Hurricane Planning Commission Meeting Agenda

December 14, 2023
5:00 PM

Agenda Date:	12/14/2023
Application Number:	ZC23-26 PSP23-39
Type of Application:	Zone Change
Action Type:	Legislative
Applicant:	Ronald and Leslie Coleman
Agent:	Gerald Murray Sr
Request:	A zone change from R1-10 to Planned Commercial
Location:	560 N 1380 W
Zoning:	R1-10
General Plan Map:	General Commercial

Agenda Date:	12/14/2023
Application Number:	ZC23-23 PSP23-40
Type of Application:	Zone Change and Preliminary Site Plan Application
Action Type:	Legislative
Applicant:	Western MTG & Realty Co
Agent:	Karl Rasmussen
Request:	A Zone Change from RM-3, multifamily 15 units per acre; R1-6, single family residential one unit per 6,000 sq ft; R1-15, single family residential one unit per 15,000 sq ft; OS, open space, and HC, highway commercial to RM-3, multifamily 15 units per acre and PC, planned commercial.
Location:	Near the future corner of Sand Hollow East and Flora Tech Road
Zoning:	RM-3, R1-6, R1-15, OS, HC
General Plan Map:	Planned Community

ZONE CHANGE MAP FOR:

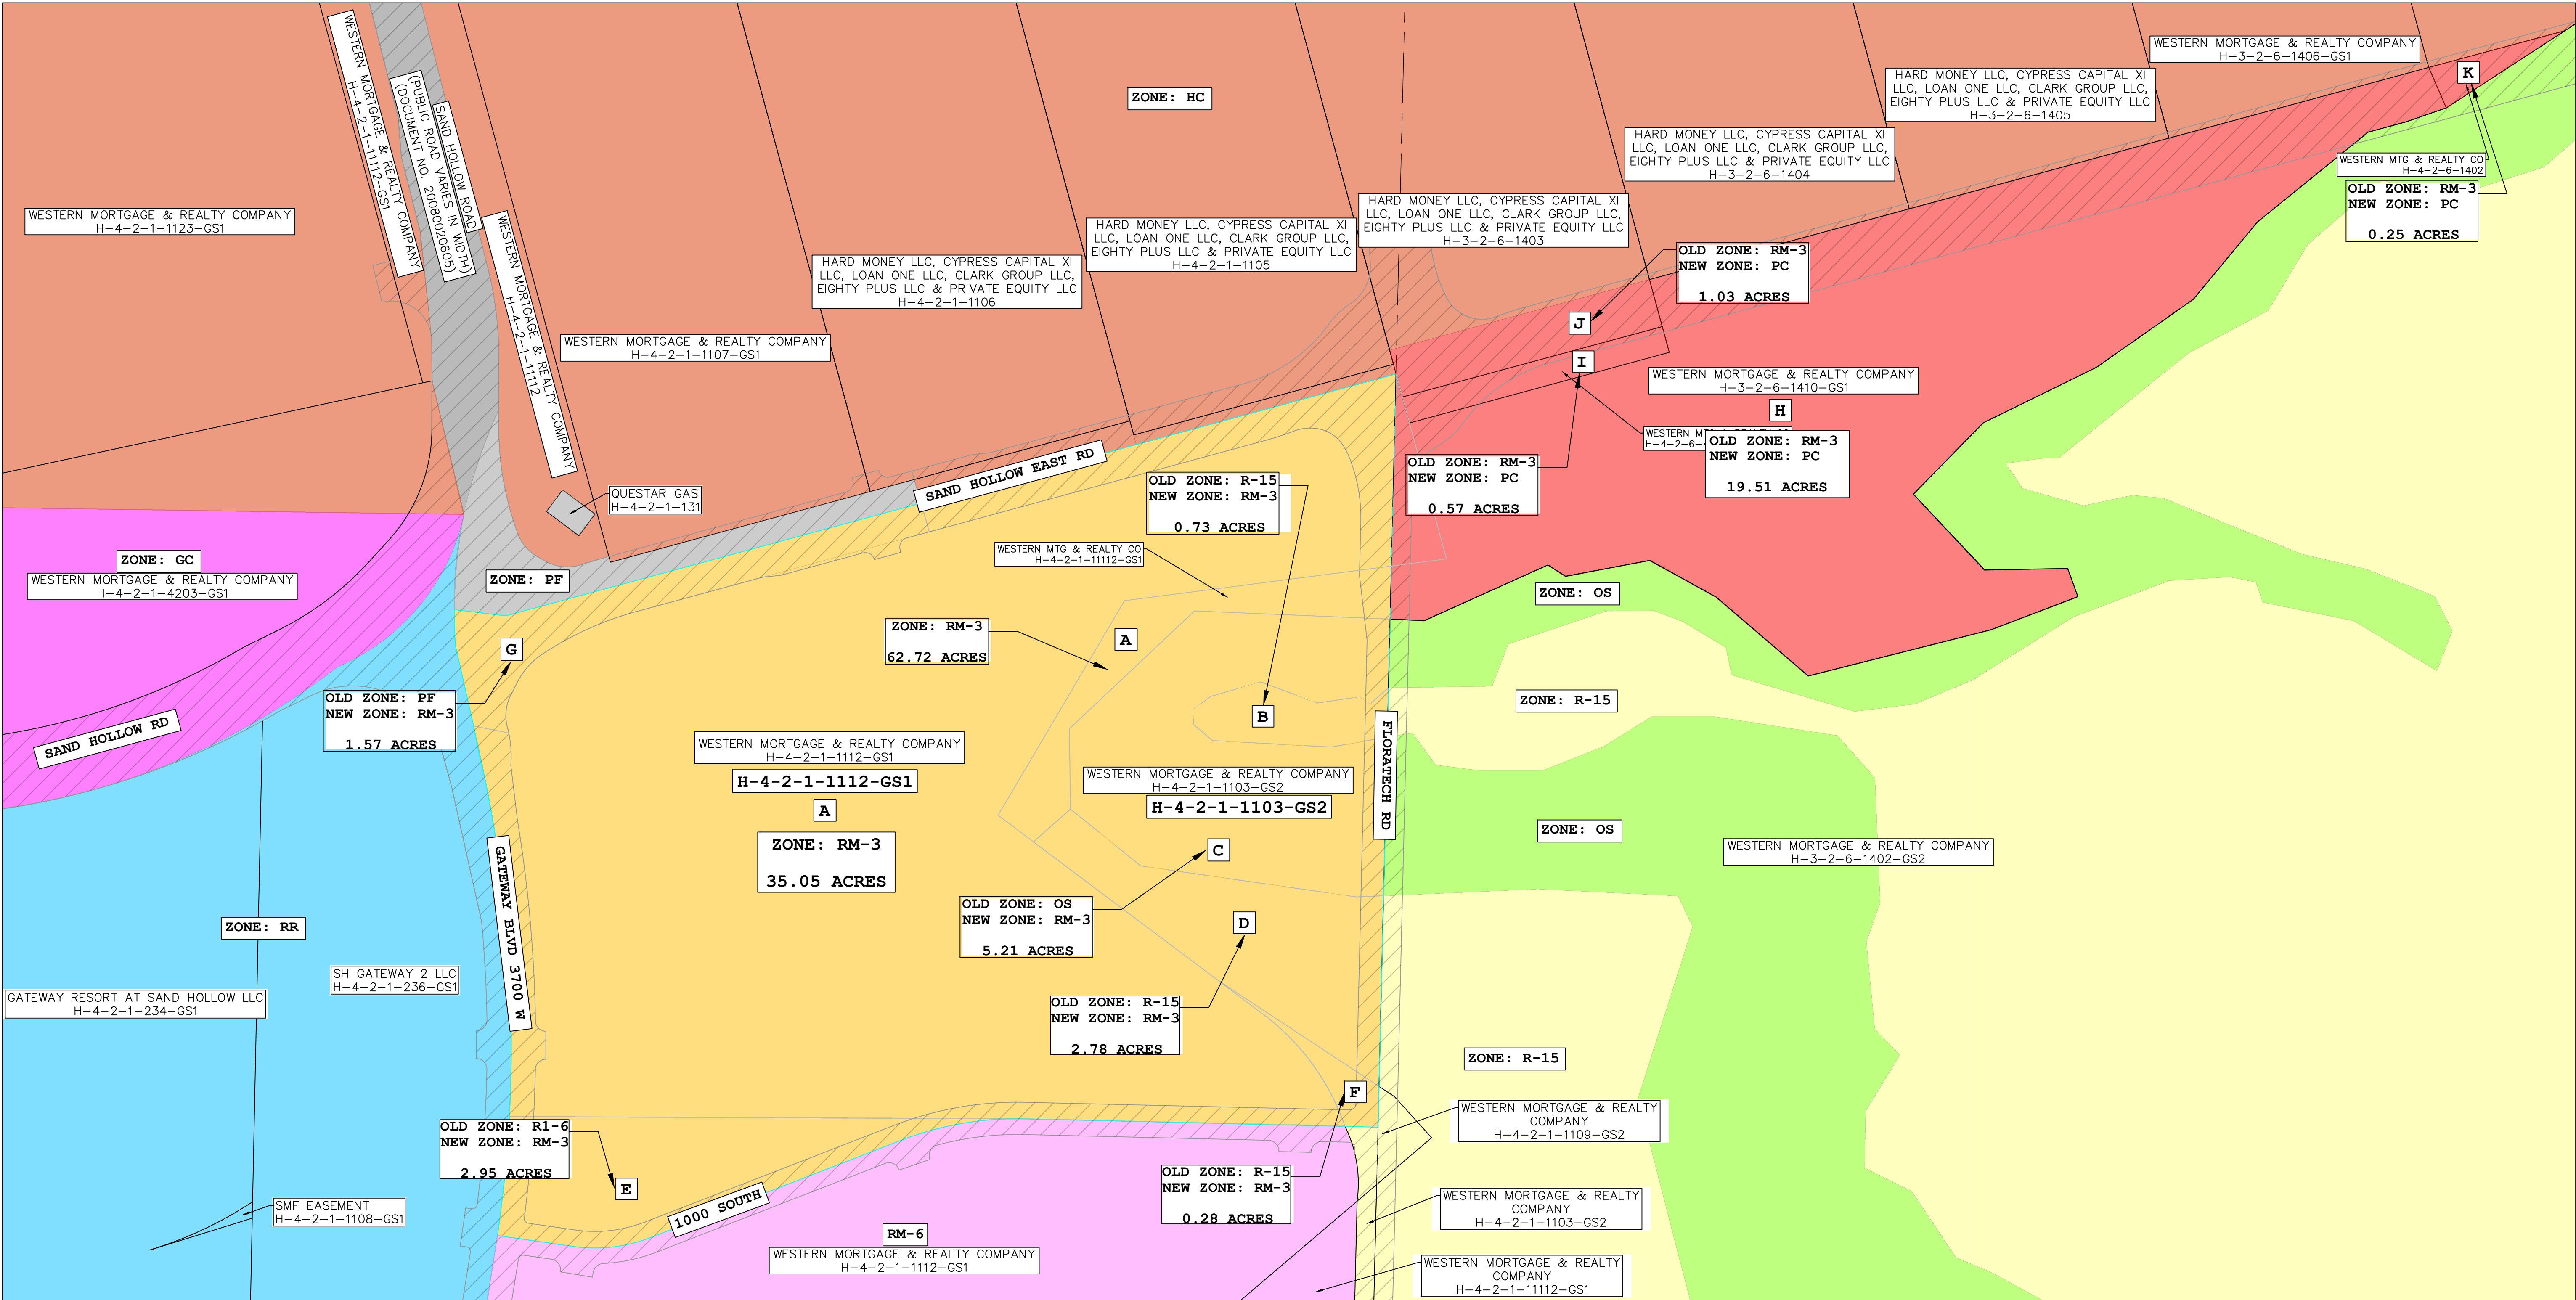
1. The applicant is proposing two projects, an RM-3 project and a Planned Commercial project. The zone change, if approved, would increase the density in this area by 198 units (from ~320 to 525) for the RM-3 zoning. Since Planned Commercial would allow a smaller overall density, and since commercial space has to be provided, they decrease their permitted units by at least 20% and their proposed site plan only calls out 96 residential units in the PC piece.

- a. The original zoning for this area approved, at most, 720 units in this area. Assuming the site plan presented for the PC piece is adhered to, and the RM-3 zoning is built out at maximum density, then they are proposing 621 units.

- b. The maximum number of units possible on the PC piece is 265 units, however their site plan shows 96 units.
2. 283 units within the RM-3 portion have already been approved with a preliminary site plan.

Recommendation: Staff recommends this item be tabled or continued to address JUC comments. While staff is supportive of the proposal, more detail on the proposed roadway alignments, specifically on Flora Tech road, should be provided.

SITE PLAN FOR:
SAND HOLLOW ROAD EAST COMMERCIAL

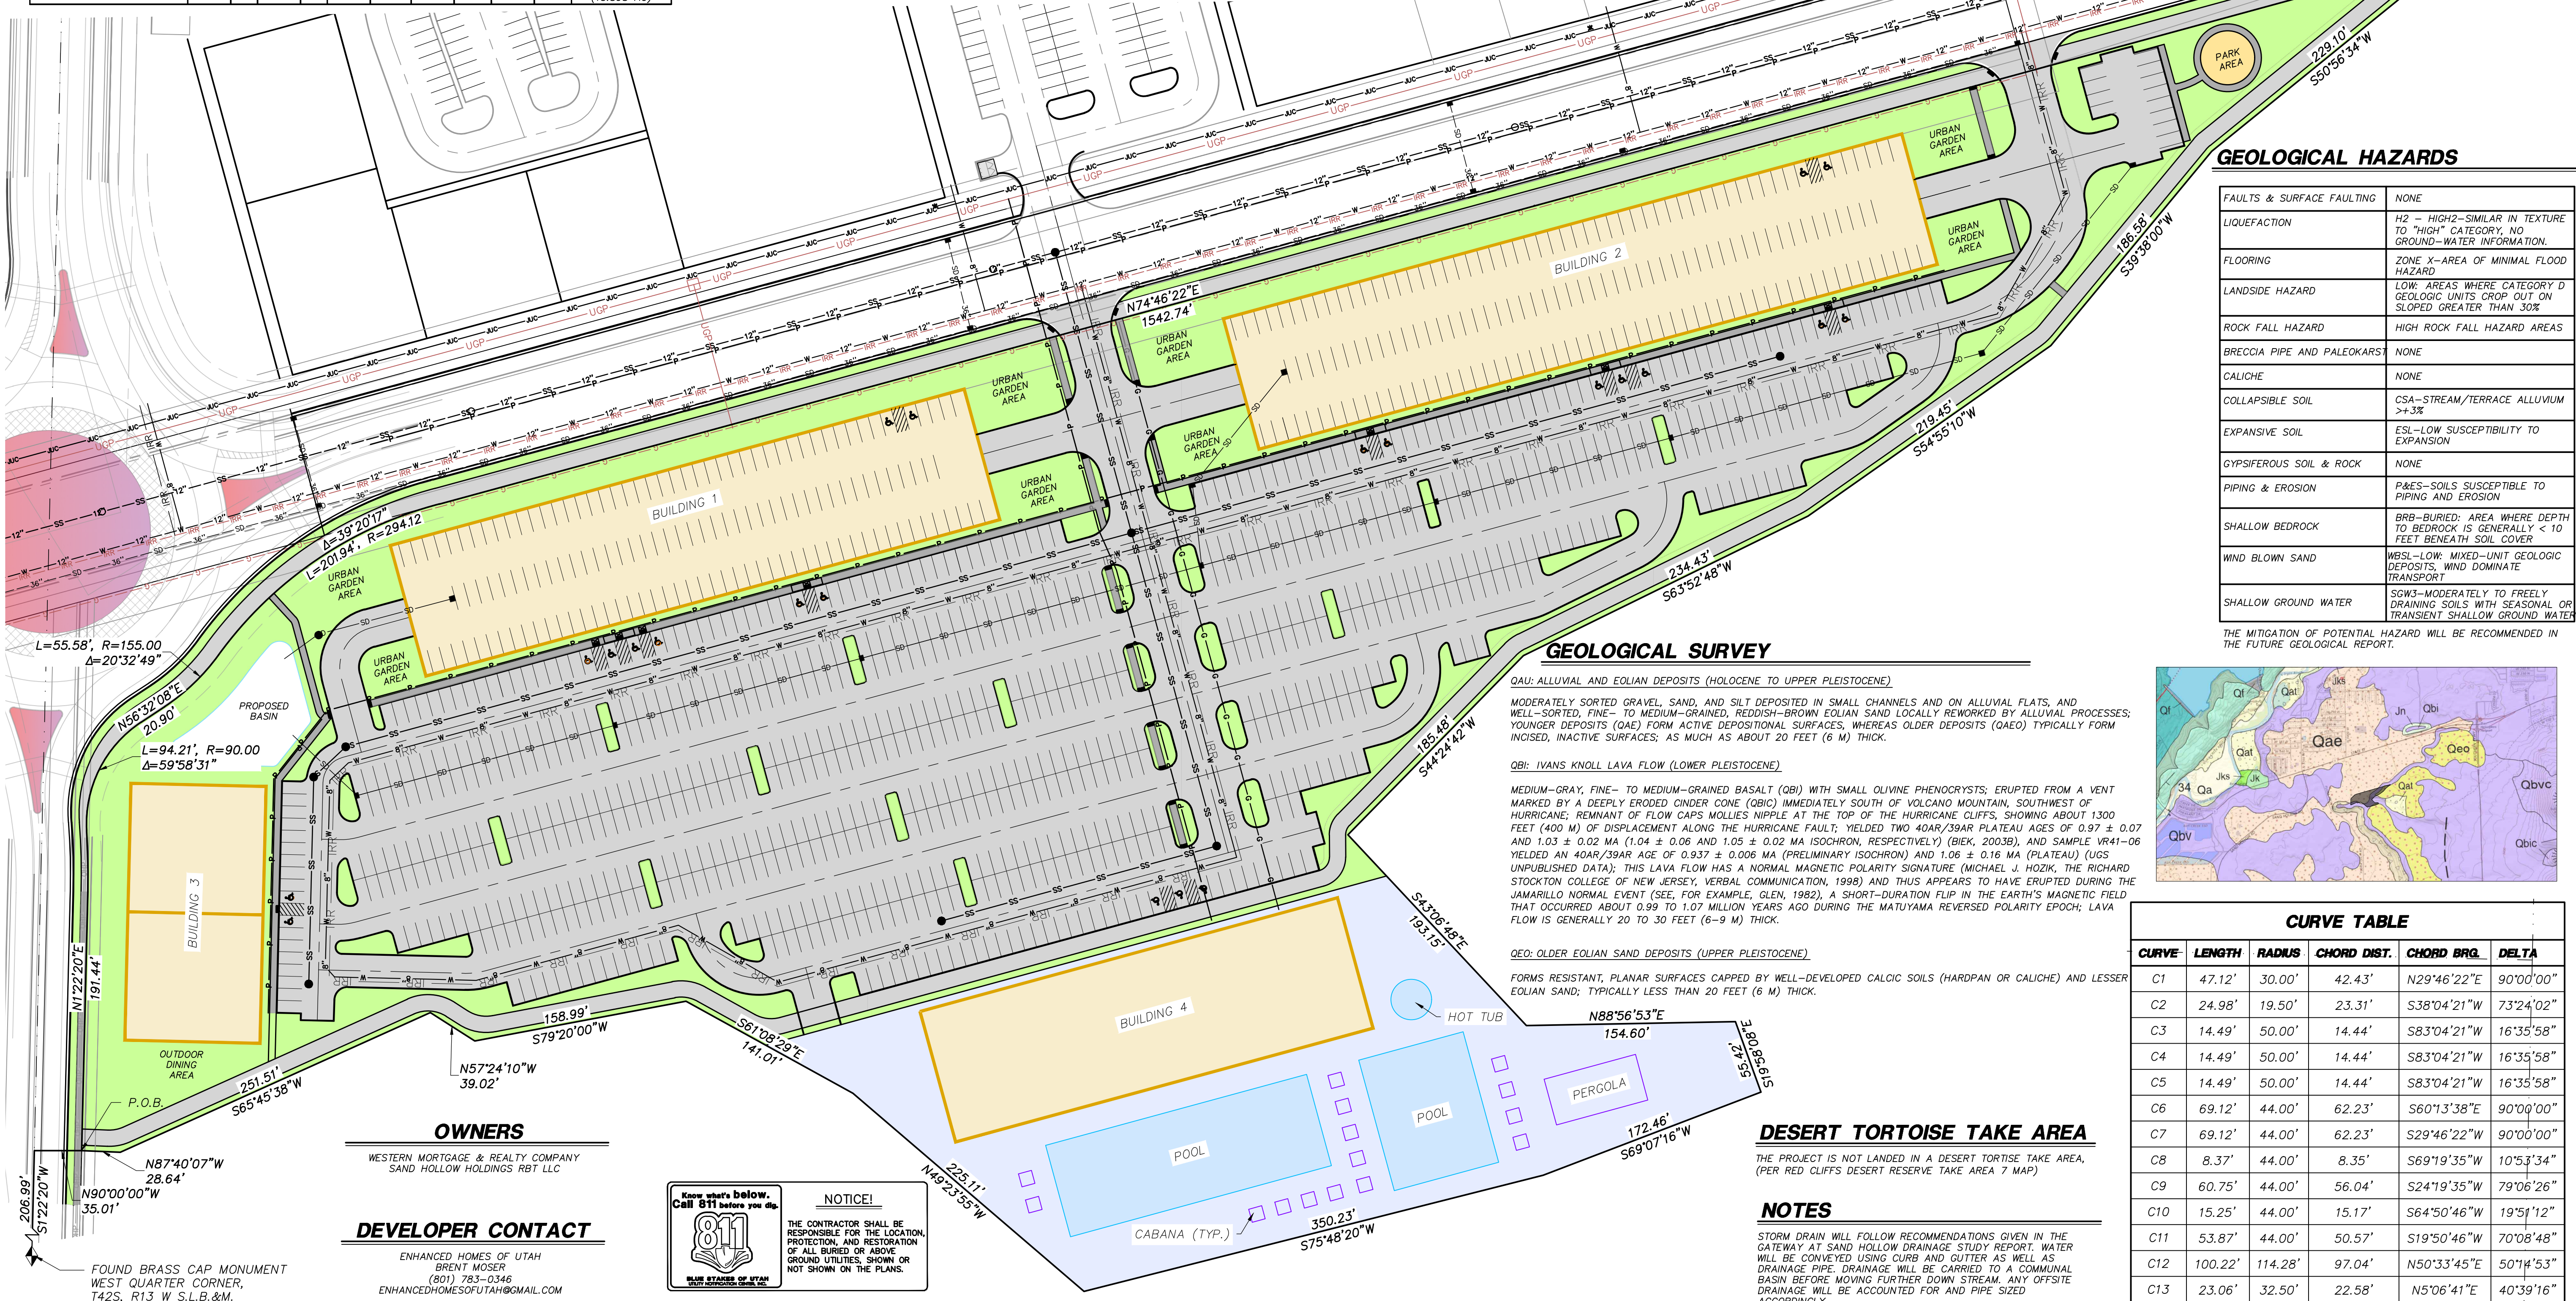
- b. **Site Plan:** The site is approximately one thousand feet from the nearest road with construction plans or an existing local road. The site is approximately 1500 feet from SR-9. Engineering anticipates that Sand Hollow Road East will be a 5-lane major arterial with 12' trails on both sides (112' cross section) to replace the minor arterial and minor collector shown in this area on the Transportation Master Plan. Sand Hollow Road East will reduce to a 3-lane minor arterial with 12' trails on both sides (90' cross section) further east than this site but before climbing the ridge. Site plan calls this out as a "high rock fall hazard" area city code states no buildings in any rockfall zone. Existing grades should be highly considered when proposing a realistic layout. The applicant and Engineering should coordinate more on the alignment of Flora Tech Road before the applicant spends too much time designing adjacent sites. The site is crossed by significant natural drainage. Hurricane City's storm drain master plan indicates a 72" pipe is needed to capture its flow; whereas, the PID's storm drain master plan specifies two 48" storm drain pipes are needed to capture and convey flows at Sand Hollow Road and Sand Hollow East. Building 4 and its anticipated amenities don't seem to account for this.

3. As stated in Engineering's comment above, this site may need to be entirely redesigned to account for increased grading for Flora Tech Road, rockfall hazards, and the significant drainage this site receives. Staff recommends that if the zone change is approved a new preliminary site plan be required that addresses those concerns.

5. **Open Space and Amenities:** Per City ordinance, 20% of the property must be dedicated open space. Per their calculations, 19.6% of the property is landscaped open space, which will need to be raised to 20%. For the number of residential units proposed, three (3) amenities should be provided, and per their plans, a clubhouse, pool, and "urban garden" are shown.

6. **Access and Roadways:** As mentioned above, the plans depict Flora Tech Road going straight along the section line to the 3400 W and SR-9 interchange instead of going around a large bluff, as depicted on the original plans. While a straight north-south alignment would be preferable for traffic flow reasons, going through a 40 foot tall bluff may be impractical. Engineering has requested more detail on grades and alignments for Flora Tech Road, but those have not been provided for at the time of this writing.
